Letter from C. R. Steinhardt (WPSC)

May 17, 1994

PROPOSED TS AMENDMENT NO. 129

Description of Changes, Safety Evaluation,
Significant Hazards Determination,
and Environmental Considerations

INTERNAL CONTAINMENT SPRAY

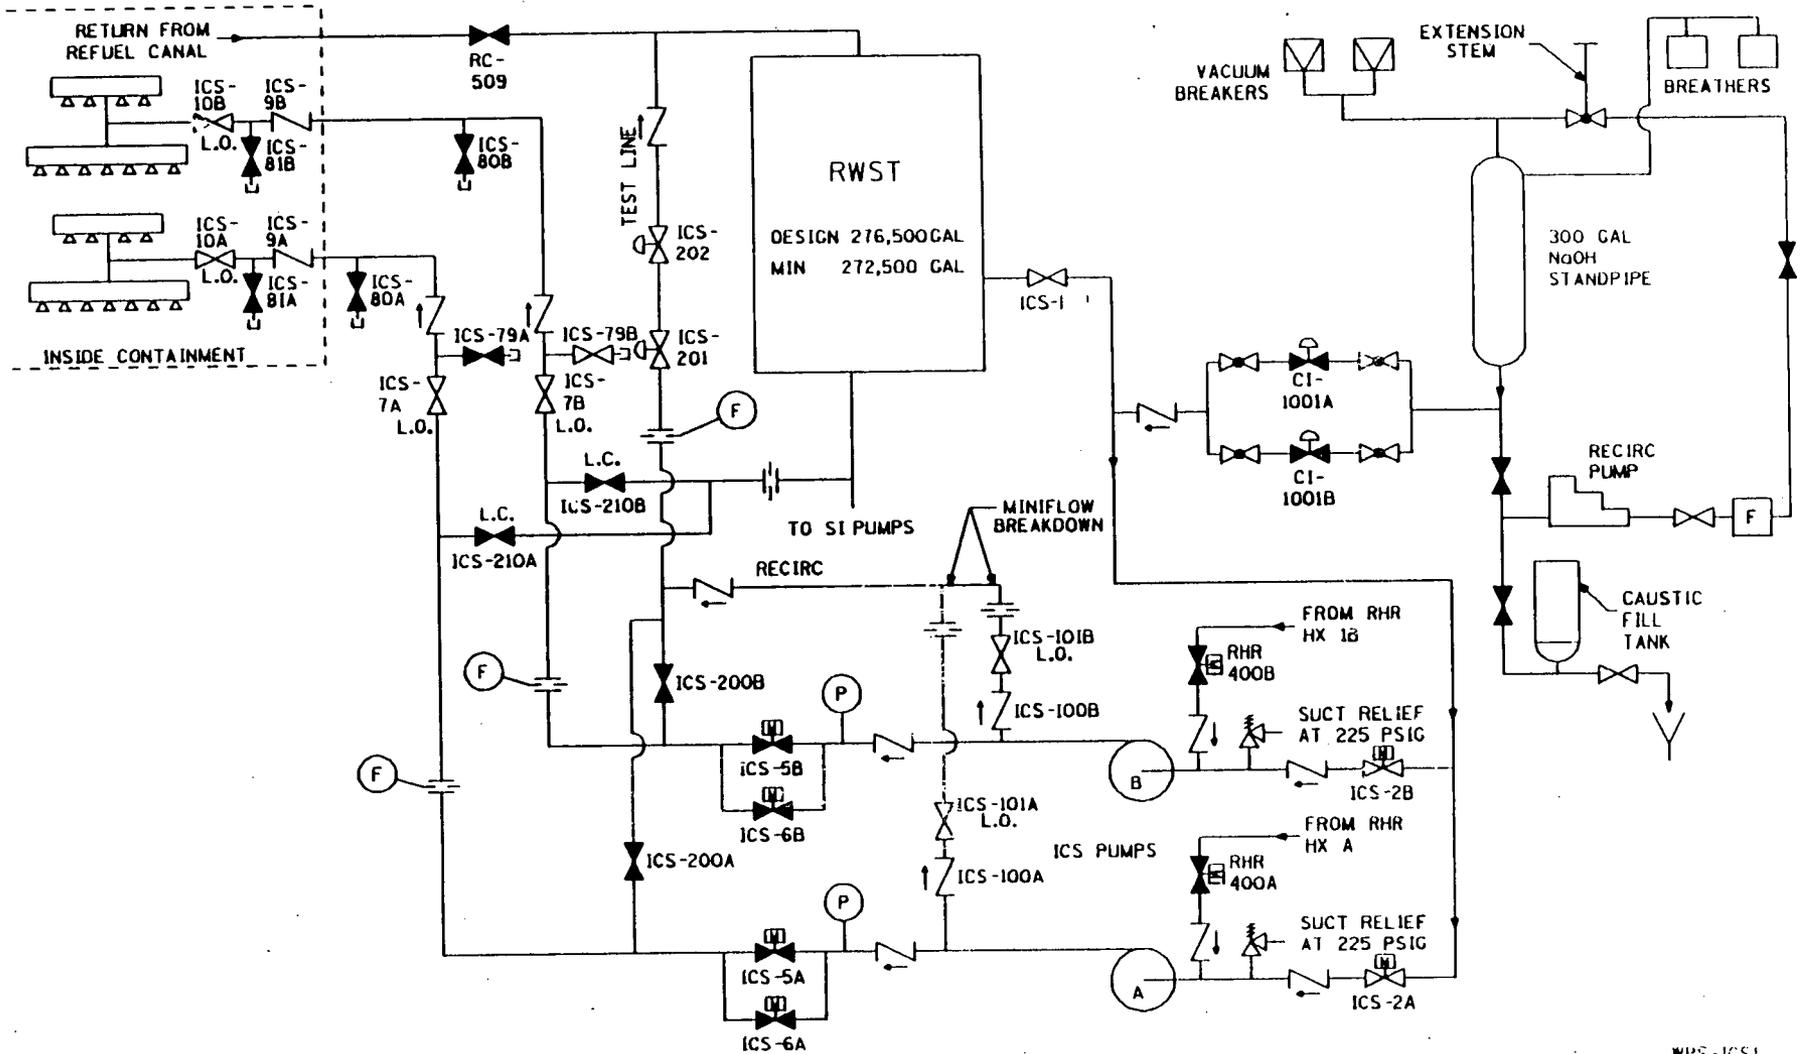
Current TS 3.3.c.2.C allows one containment spray train to be inoperable for 72 hours with the standard shutdown sequence invoked when two ICS trains are declared inoperable. Current TS 3.3.c.2.A permits the containment spray caustic additive volume to be less than required for 48 hours (thus making the Spray Additive System inoperable). This results in conflicting guidance during the periodic testing of valves CI-1001A & B. When these valves are closed, this isolates the spray additive system, and would strictly require that both ICS trains be declared inoperable. A sketch of the ICS system is provided as Attachment 1, Page 5.

1. The words "and the spray additive tank upon a Hi-Hi containment pressure signal and after manual transfer" have been removed from former TS 3.3.c.1.B.2 (new TS 3.3.c.1.A.1.b.)

1. Former TS 3.3.c.2.A which stated, "The quantity of NaOH solution available as a containment spray additive may be less than that specified in TS 3.3.c.1.A for a period of 48 hours" has been changed to allow the Spray Additive System to be out of service for 72 hours, and is incorporated into new TS 3.3.c.2.A.3.
2. A new TS, TS 3.3.c.2.A.2, is being added which reads "Valves and piping are capable of adding NaOH solution from the additive tank to a containment spray system."
